STATE OF OHIO
DEPARTMENT OF TRANSPORTATION

HAM-75-14.61

1 2-19-2021 - Added Sheet 444A

PLAN VIEW LINEAR BIORETENTION CELL IN GRASS DITCH
 NOT TO SCALE

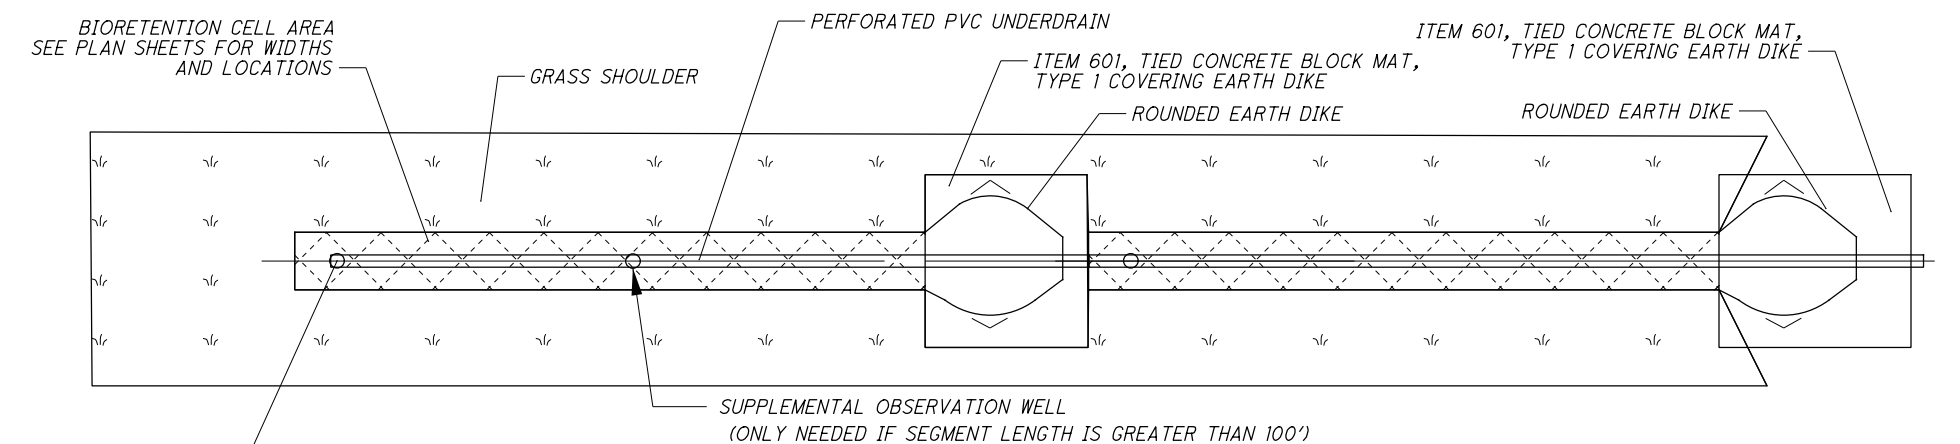
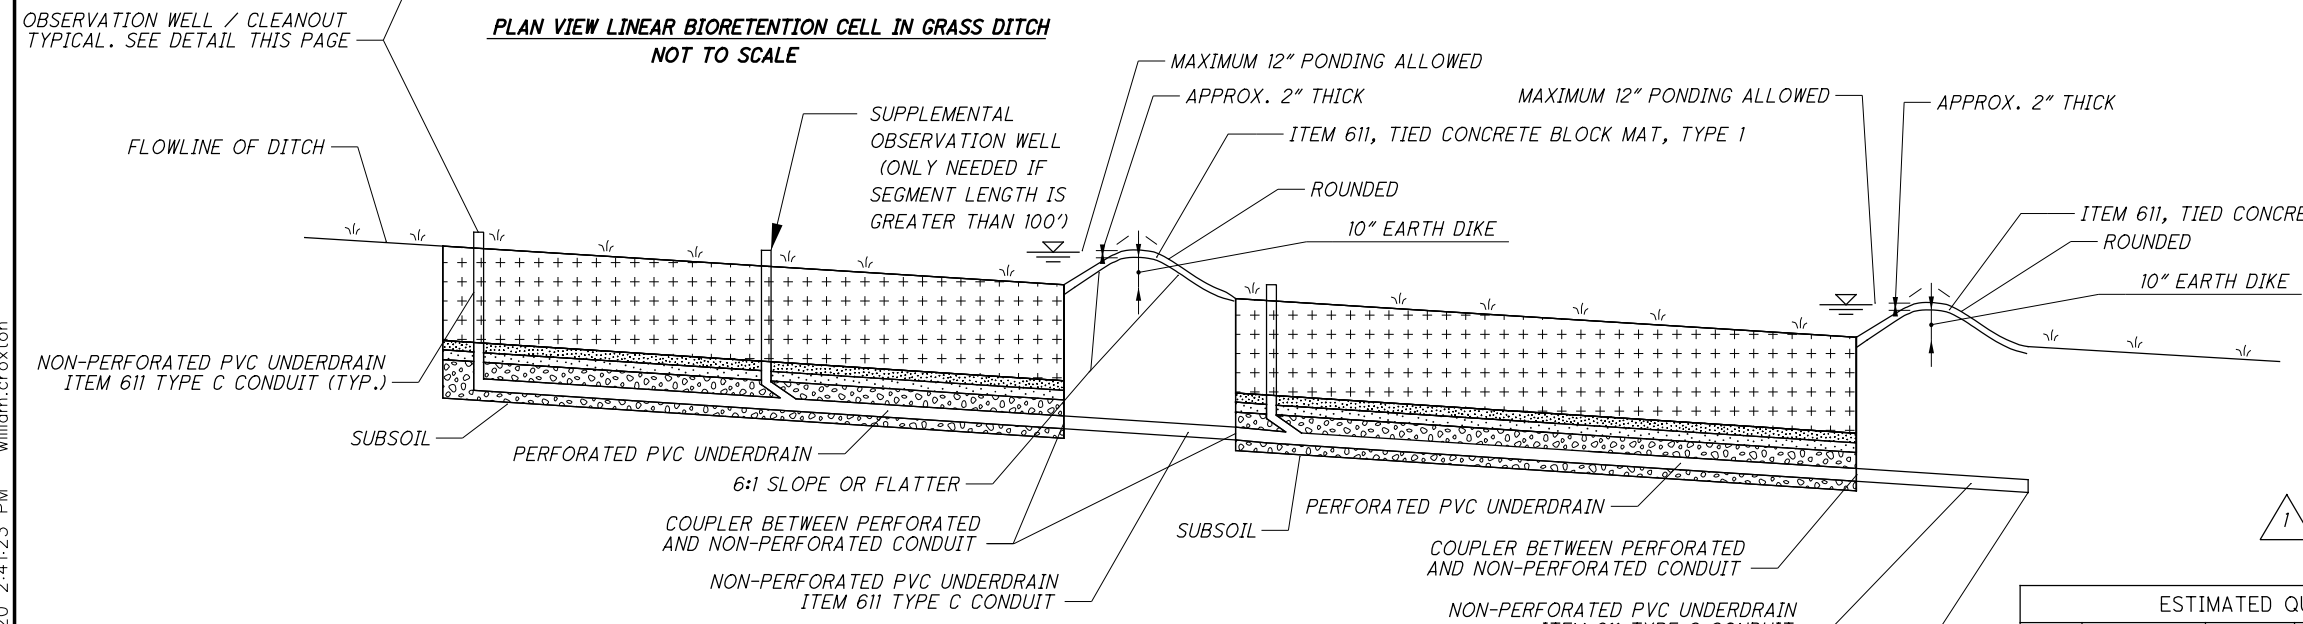
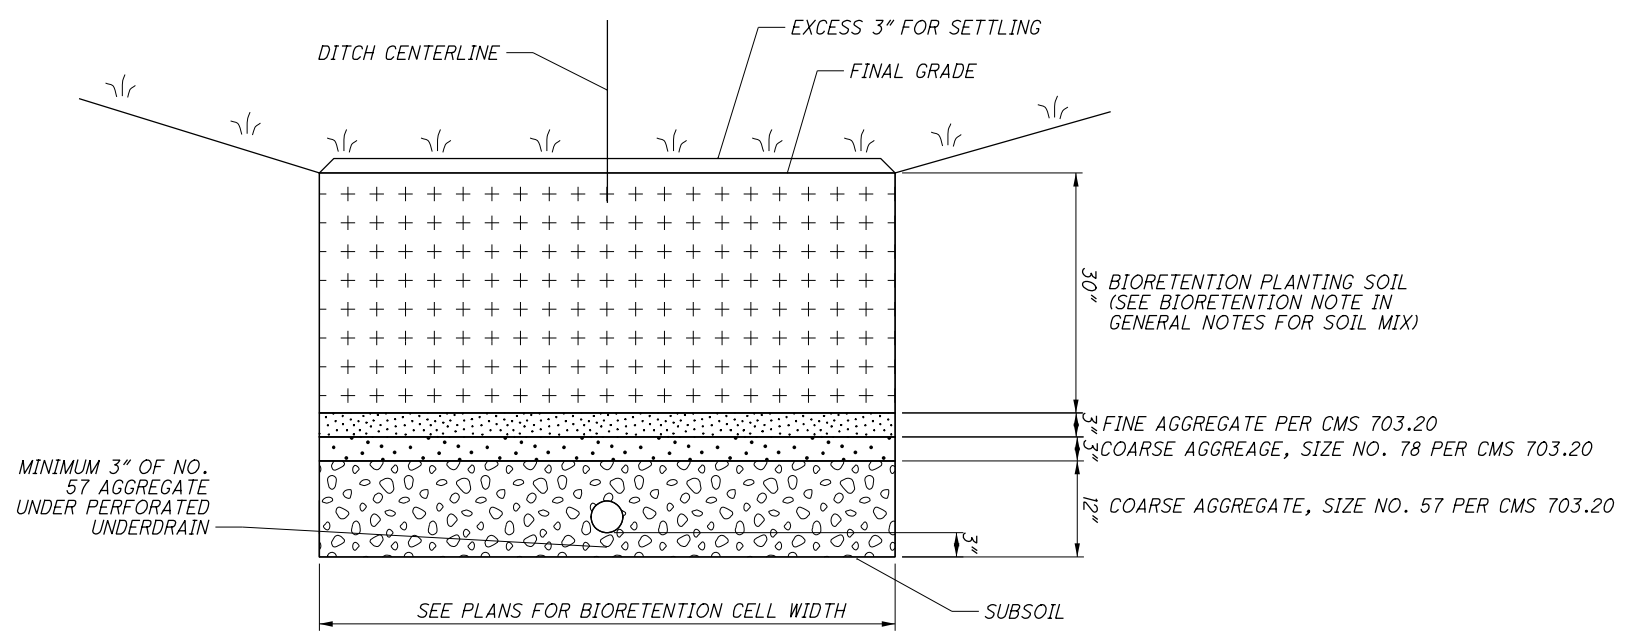
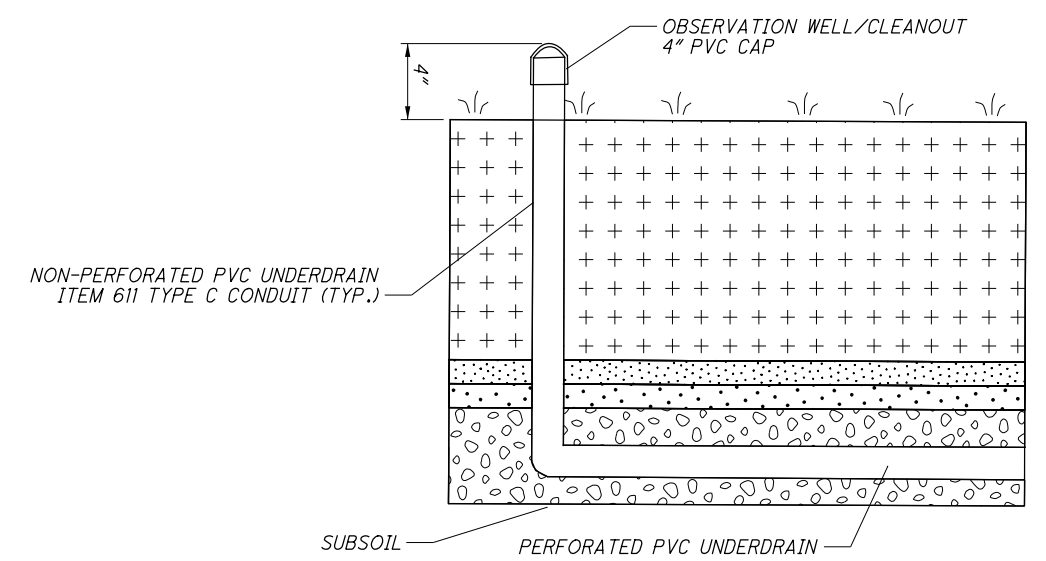
1 2-19-2021 - UPDATED TO ITEM 203-EXCAVATION, AS PER PLAN
